River District Design Commission

JANUARY 14, 2021

AGENDA

STAFF REPORT

A.1
SHEET 1 OF 3

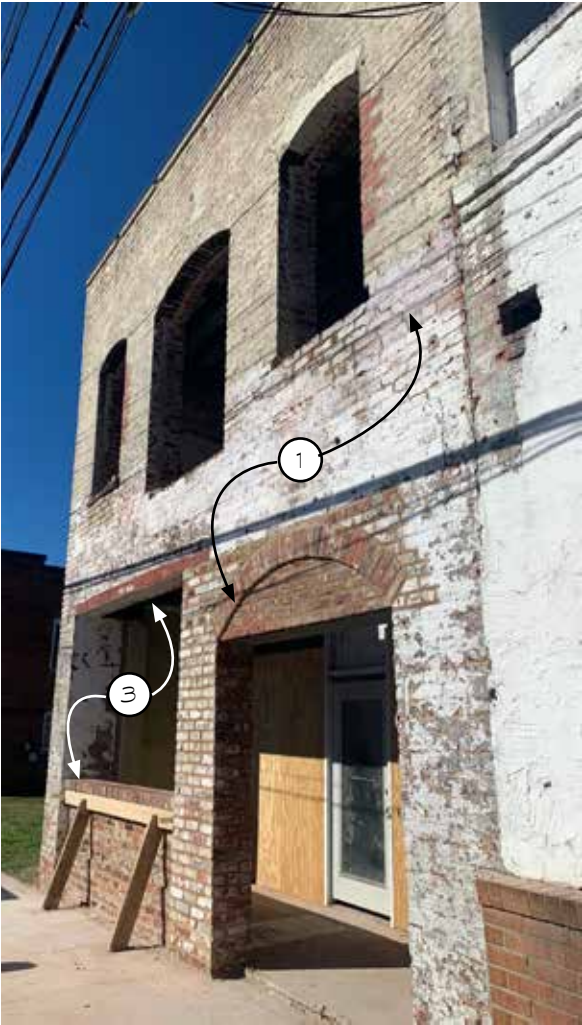
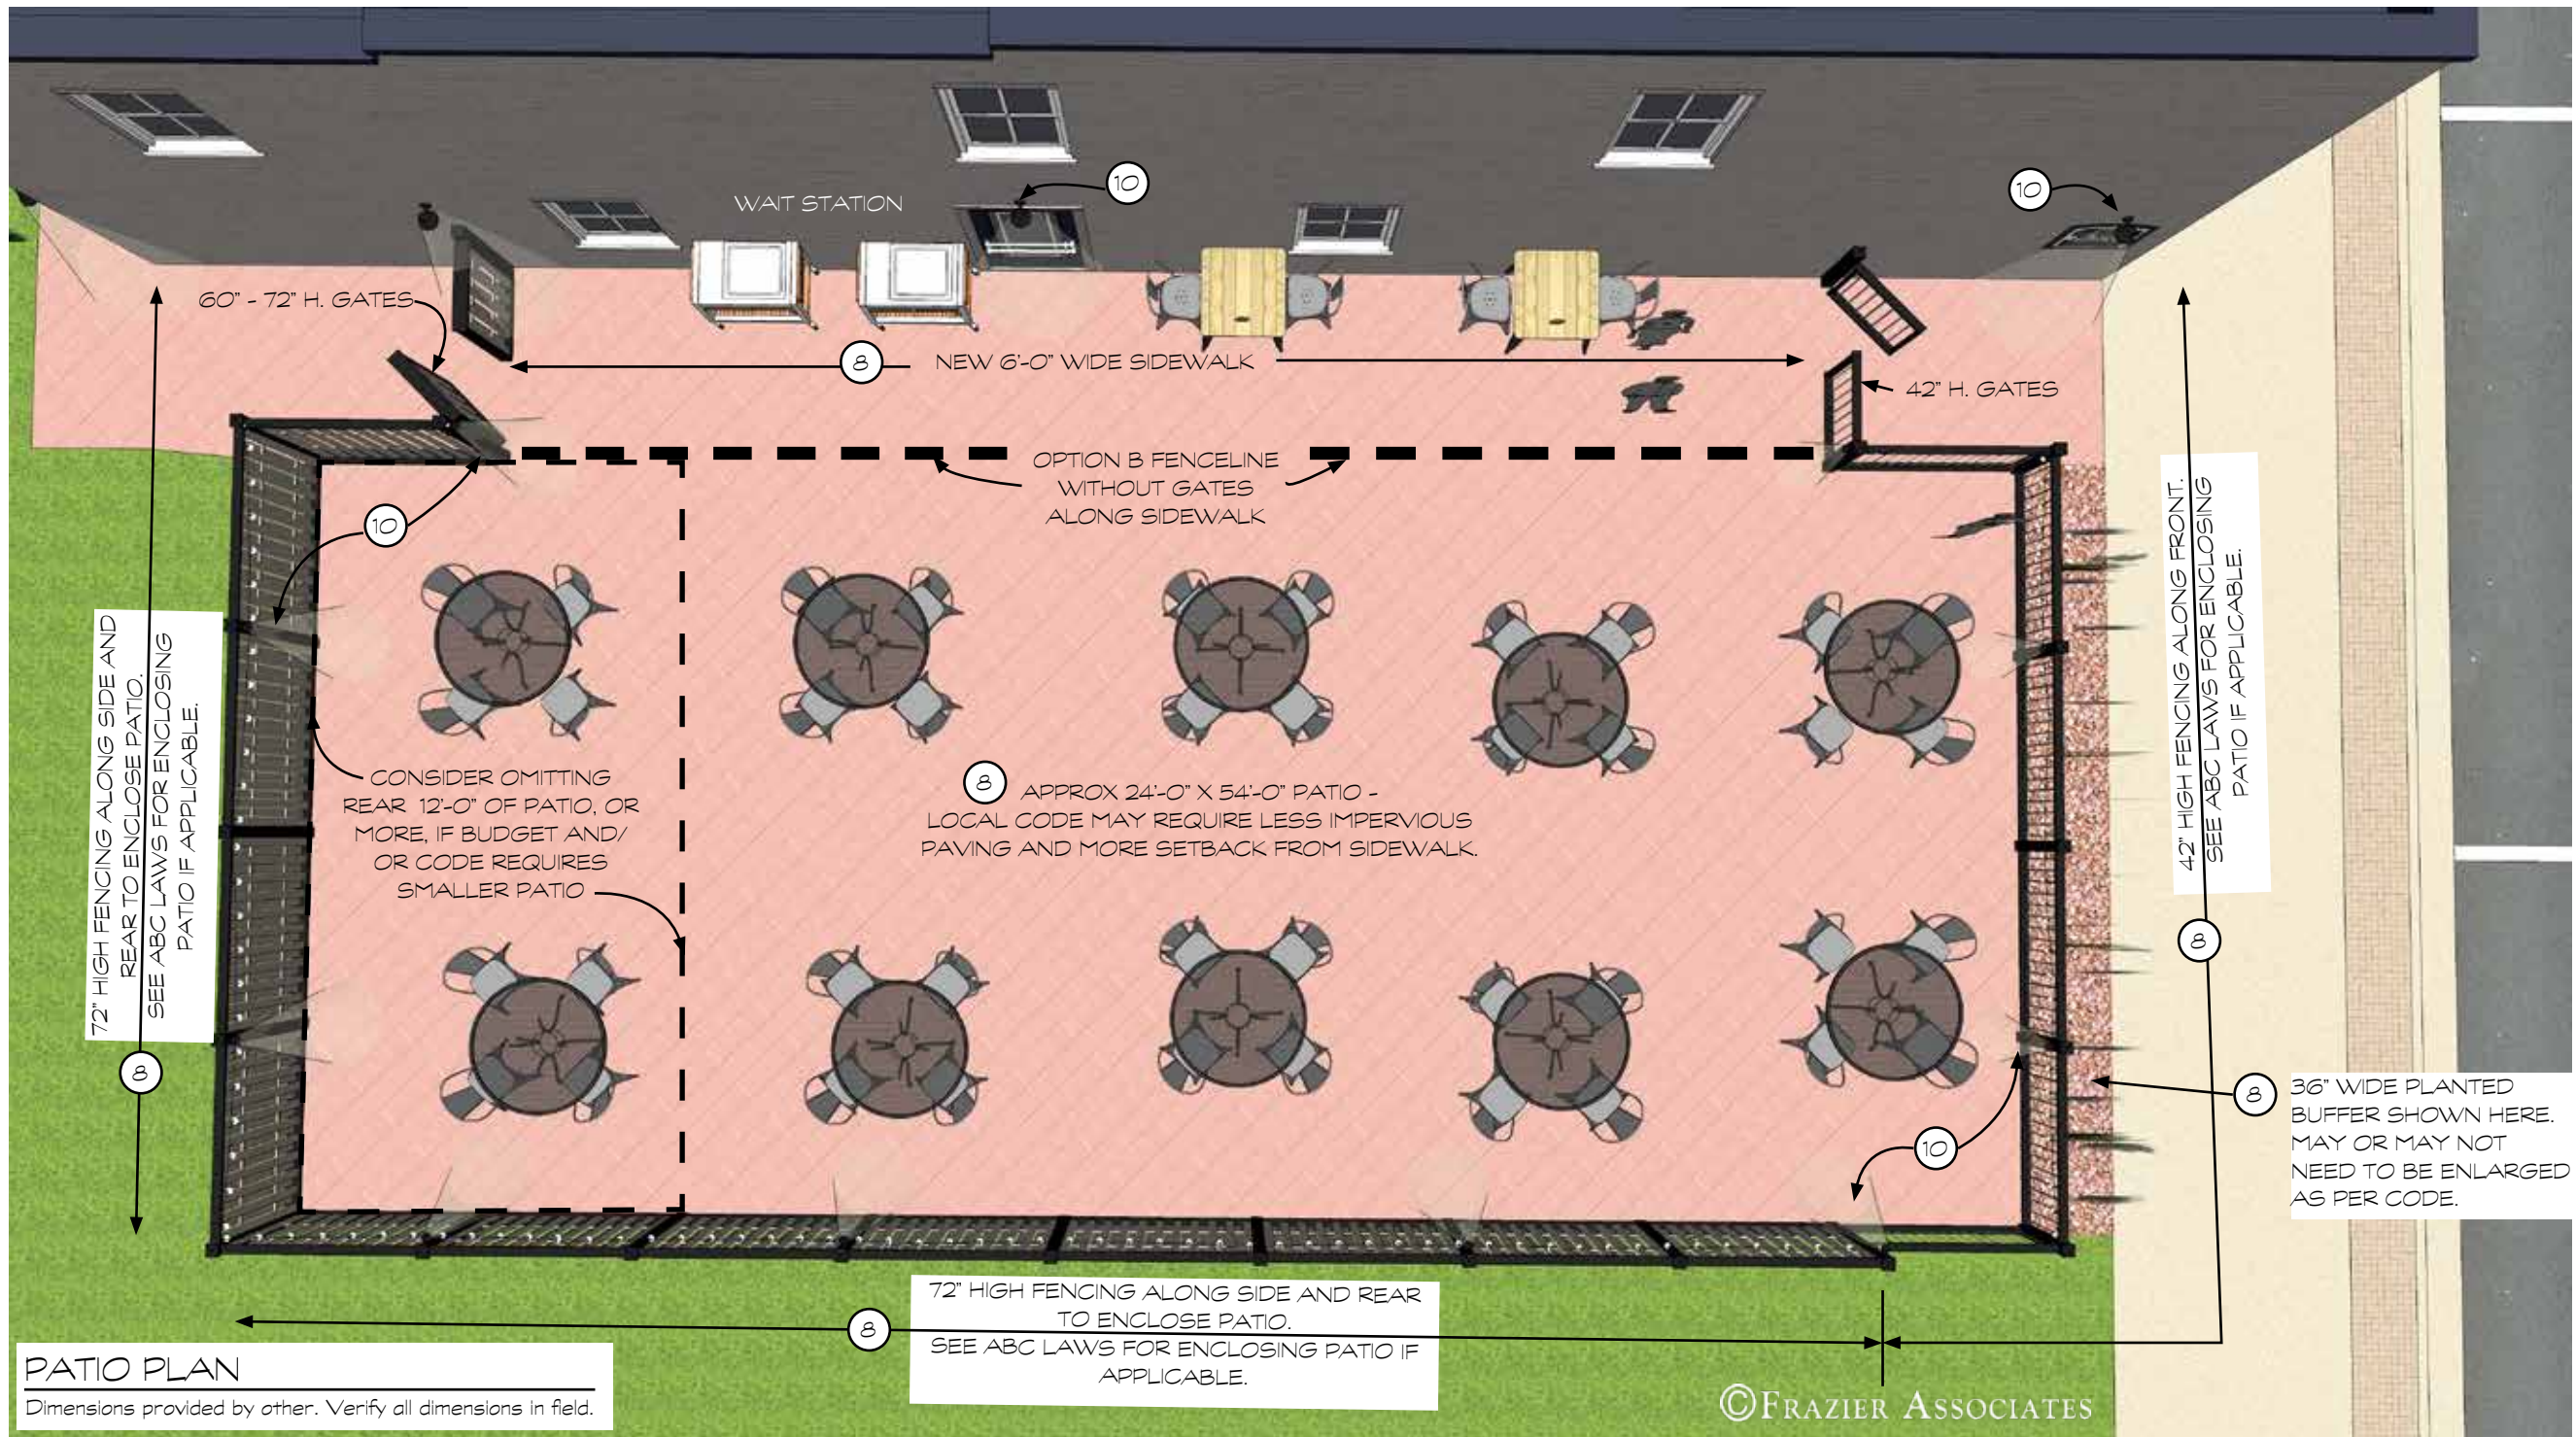
1. To remove the dilapidated non-historic brick veneer and loose plaster on 508
2. Remove sections of the existing street facing wall to create two storefront windows to match 510 spring street once the renovation is complete.

- a. Please see drawing A-1 and A-2 for references on both the existing and proposed (we do not wish to add the take-out door as suggested in drawing on A-2)

3. Change prior approved storefront window for 510 Spring to aluminum instead of wood framed. (This will allow all three openings to match)
4. To create a 30' x 54' outdoor patio on the adjacent lot (Parcel ID 22434) and sidewalk entrance to 510 Spring St.
